**CITY OF VANCOUVER
PLANNING & DEVELOPMENT SERVICES**

**DEVELOPMENT PERMIT STAFF COMMITTEE
MEETING**

**FOR THE DEVELOPMENT PERMIT BOARD
March 18, 2019**

**3591 W 19th Ave (COMPLETE APPLICATION)
DP-2018-00329 – C-2**

Figure 2: West Elevation (Dunbar Street)

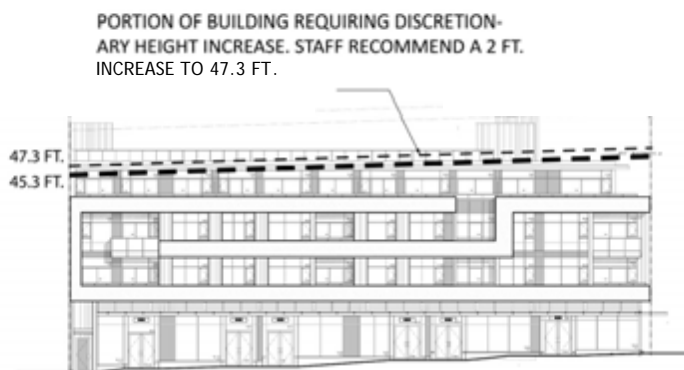
The site slopes down to the north along Dunbar Street by about 4.33 feet and to the lane from Dunbar Street by approximately 9 feet creating a cross-slope of over 13 feet. In the case of this particular context, the outright permissible building height of 45.3 feet would result in low floor-to-floor height for some commercial units. In order to meet the intent of the C-2 District Schedule with respect to providing viable commercial space, staff support a 2 foot increase of the building height to allow for 13 feet to 16 feet floor-to-floor height in the commercial spaces. (see Figure 2)

Figure 4: North Elevation

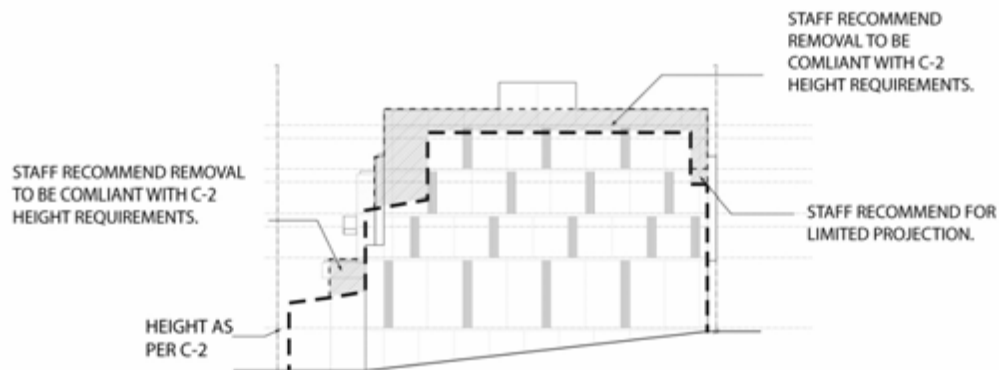
A portion above the loading enclosure exceeds the height envelope by approximately 10 feet (see figure 4). Staff recommend eliminating the protrusion to conform to the height requirement. See Recommended Condition 1.3.

The profile of the party wall exceeds the height envelope at a few locations (see figure 4). Staff recommend removing the protruded portions in order to minimize the party wall visual impact and create a better interface with future adjacent development. See Standard Condition A.1.3. Note that staff can consider minor extensions of party wall to accommodate Vancouver Building Bylaw (VBBL) requirements.

Above 35 feet in height an 8 foot front setback is required to reduce apparent scale of the building. A portion of the north end of the building projects into the 8 foot setback (see figure 4). Staff support the limited projection into the setbacks based on the consideration of site slope condition.
